# **Review of proposed amendments to Water Quality Control Plan for California Ocean Waters to address desalination facility intakes, brine discharges, and to incorporate other non-substantive changes**

E. Eric Adams, PhD, PE  
Dept. of Civil and Environmental Engineering  
Massachusetts Institute of Technology  
Cambridge, MA 02139

Sept 9, 2014

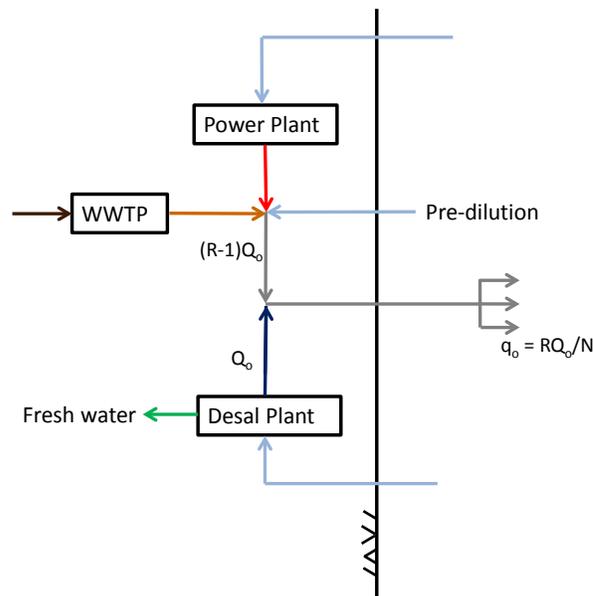
The above equations are for a single jet discharging just the brine from a desalination plant. The accompanying sketch depicts an arrangement where the discharged flow can be pre-diluted with either: i) seawater, ii) treated wastewater effluent, and/or iii) heated condenser cooling water from a power station, making a combined flow of  $RQ_o$ . The discharge is evenly distributed through  $N$  ports of a multiport diffuser making the flow per port equal to  $RQ_o/N$ . The reduced gravity of the combined flow is  $[\Delta_o + (R-1)\Delta_p]/R$  where  $\Delta_p$  is the reduced gravity of the pre-dilution flow, which is proportional to the pre-dilution excess salinity, i.e. [ $g(\rho_p - \rho_a)/\rho_a$ ]  $\sim \Delta s_p$ , defined as positive for a dense flow. For example, if the pre-dilution comes from pure seawater  $\Delta_p = \Delta s_p = 0$  while if it comes from treated wastewater effluent or heated condenser cooling water  $\Delta_p$  and  $\Delta s_p < 0$ . Using Eqs 1b, 2b, the maximum plume height and the dilution are

Eqs 3-5 are exercised in the accompanying table. Note that for a given problem  $Q_o$  and  $\Delta_o$  are fixed, while  $\theta_o$ ,  $R$ ,  $u_o$ ,  $N$  and  $\Delta_p$  are design variables. Case 1 starts with base case parameters that do not meet a target near field dilution of 20 either for excess salinity  $\Delta_s$  or excess concentration  $\Delta_c$  (last two columns of the table). The remaining cases show that dilution increases (and a target of 20 can be easily achieved) by using a multi-port diffuser (increasing  $N$ ; Case 2), increasing discharge momentum (increasing  $u_o$ ; Case 3), pre-diluting the brine with neutrally buoyant seawater (increasing  $R$  with  $\Delta_p = 0$ ; Case 4), and pre-diluting (co-mingling) the brine with relatively buoyant treated wastewater or heated water (increasing  $R$  and making  $\Delta_p < 0$ ; Case 5).

So all of these options can provide improved dilution. On the negative side, increasing  $u_o$  and  $R$  may require deeper water depth or shallower discharge angle to avoid plume surfacing, while increasing  $N$  allows discharge in shallower water. These are capital cost issues. And increasing either  $u_o$  or  $R$  requires more pumping energy, an operating cost issue. Environmentally, increasing  $R$  causes more water to be withdrawn at the intake with potential impacts due to impingement and entrainment, as well as impacts on the discharge side due to turbulent shear. Increasing  $u_o$  by itself could also increase turbulent shear. But if you can use another effluent (i.e., treated wastewater or condenser cooling water) for pre-dilution, then you have already suffered the impacts with sourcing and using that water, and if you are going to discharge the other effluent to the ocean anyway, you might as well let it improve your dilution. In the case of treated wastewater, however, an evaluation should be made as to whether commingling is a more valuable use than re-use (direct or indirect).

The improved dilution from co-mingling comes from both increasing  $R$  and decreasing the reduced gravity. In the case of brine, the “effective dilution” is increased further because the pre-dilution flow has negative excess salinity. This is reflected in the higher value of  $S_{ns}' = \Delta_{so}/\Delta_s$  representing the reduction in salinity, relative to  $S_{nc}' = \Delta_{co}/\Delta_c$  representing the reduction in concentration. Indeed, if  $[\Delta_o + (R-1)\Delta_p] = 0$ , the effluent would be neutrally buoyant and the effective brine dilution would be infinite (Eq 4), given sufficient water depth. And if  $[\Delta_o + (R-1)\Delta_p] < 0$  the effluent would be positively buoyant. A separate dilution equation would need to be applied because the diluted effluent would float on the ocean surface, rather than fall to the seafloor. Because ambient velocities are generally higher on the surface than on the bottom, such a plume is more easily flushed in the far field, resulting in less brine build up. On the other hand, an aesthetic drawback is that the plume would be visible.
